TVGA
Engineering, Surveying, P.C.
 NO EXCEPTIONS TAKEN REJECTED
 FURNISH AS CORRECTED
 REVISE AND RESUBMIT
ENGINEER has reviewed Shop Drawings and Samples and for conformance with the information given in the Contract Documents and compatibility with the design concept of the completed Project as a foretelling whole as indicated in the Contract Documents. Such reviews do not extend to means, methods, techniques, sequences or procedures of construction or to safety precautions and programs incident thereto. Contractor is responsible for information that pertains solely to the fabrication processes or to techniques of construction; and for coordination of the work of all trades.

DESCRIPTION: STRINGER STANDARDS		DRAWN BY	DATE
JOB:	BRIDGE NO. 43N	PHG	02/09
	1-89 SB OVER U.S. ROUTE 2	CHKD BY	
	1-89 IMPROVEMENTS	TRM	02/21
	TOWN OF MIDDLESEX-BOLTON, VERMONT	APPROV BY	
		SUPERVISOR	H. J. GATTI
PROJ NO.	1M-089-2(26)	Q.A.	
CUSTOMER: VERMONT AGENCY OF TRANSPORTATION			
CASCO BAY STEEL STRUCTURES, INC.		JOB NO.	DRG. NO.
75 SPRING HILL ROAD		117-43N	X21
PHONE (207) 282-7360		FAX. (207) 282-1179	
		REV.	△

2 ~ x21aa
DRIP PL

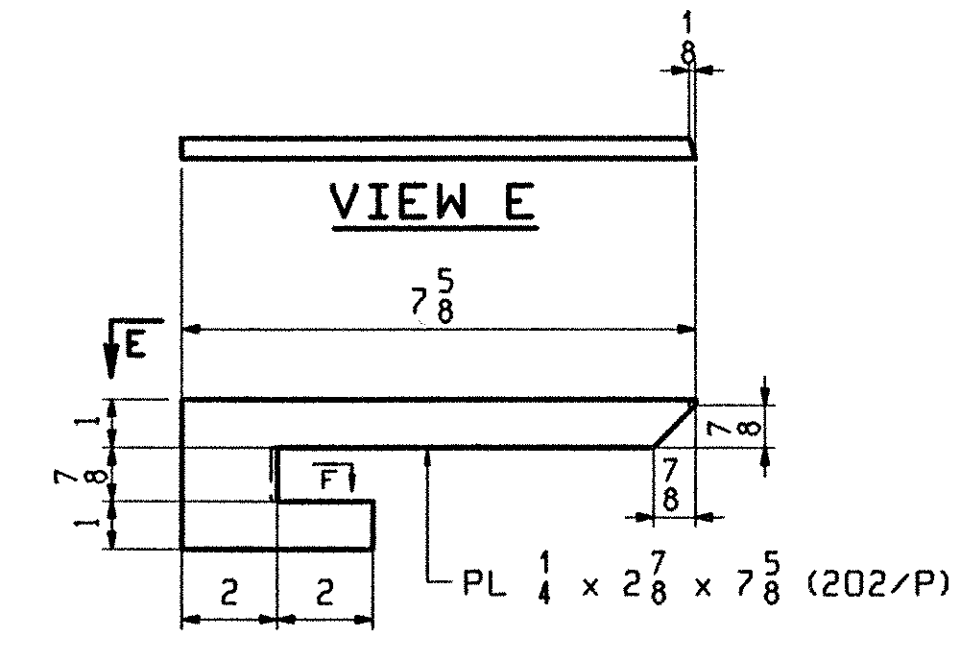
ENGR VERIFY WIDTH OF PL REDUCED TO CLEAR "K" OF W30 THICKNESS INCREASED TO 4" TO MAINTAIN NET SECTION
